12901A

FLOATING-POINT HARDWARE ACCESSORY KIT

(FOR 2100A COMPUTER)

SUPPLEMENT DESCRIPTION

Figure US-1. ROM Control Card (with Floating-Point), Parts Location Diagram

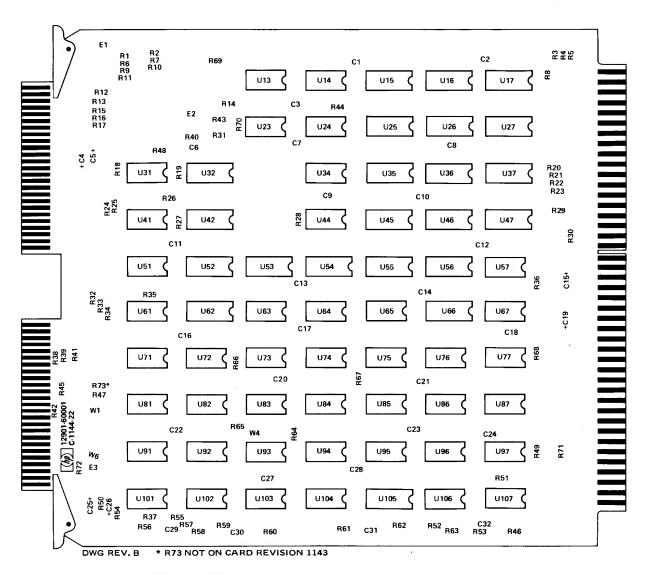
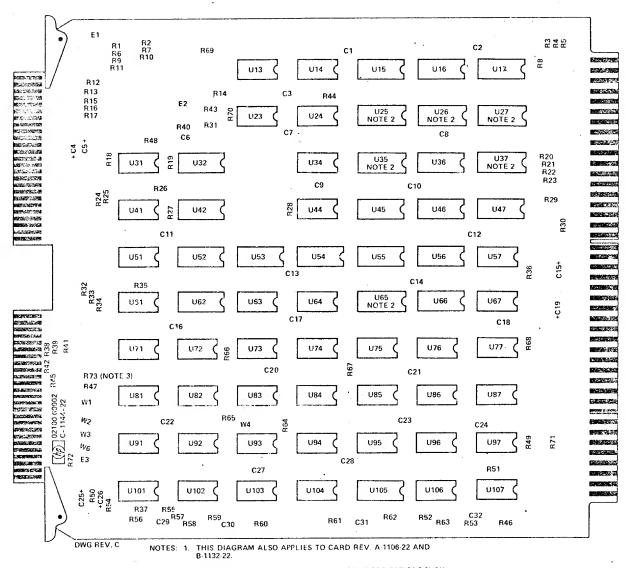
Page 4-6. Replace figure 4-1 of the manual with figure US-1 of this supplement.

- 2. U25, U26, U27, U35, U37, AND U65 USED ONLY FOR OPTIONS SUCH AS FLOATING POINT CAPABILITY.
- 3. R73 FIRST USED ON CARD REV. C-1144-22...
